## Independent peer review of Watermark Coal Project groundwater modelling report

**Client:** Caroona Coal Action Group (CCAG)

**Project Reference:** 2014015, 2014114

(Left) A geological cross section generated from the EIS by WRL. (Right) A geological cross section by WRL taken from the logs reported by Shenhua in the EIS (note the differences to the conceptual model on the left).

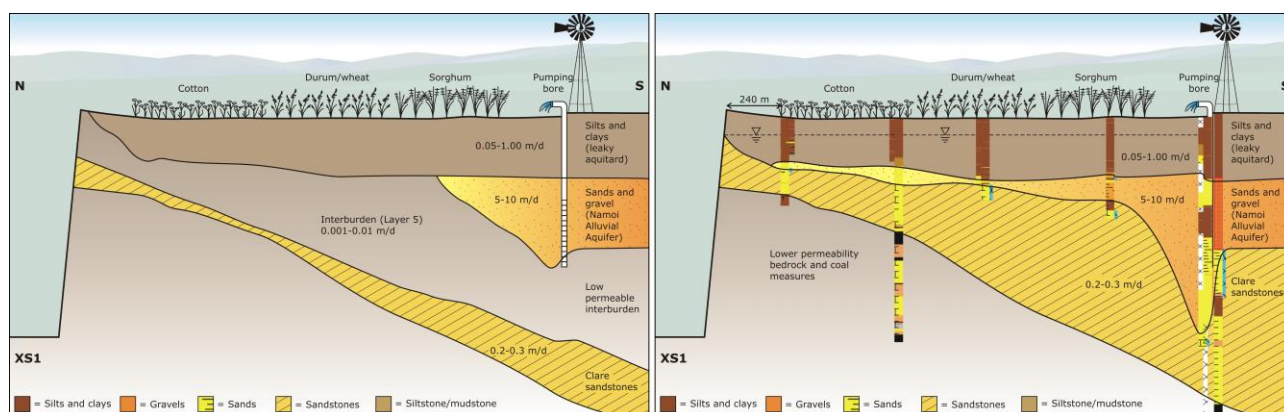
- The proponent's conceptual models relied upon select, non-unique interpretations and overly simplified representations of the available field data;
- The proponent had not satisfactorily demonstrated that all plausible alternative interpretations of the field data and geology were captured within the proponent's uncertainty and sensitivity analysis, and consequently that the bounds of likely impact were not greater than the reported impacts; and
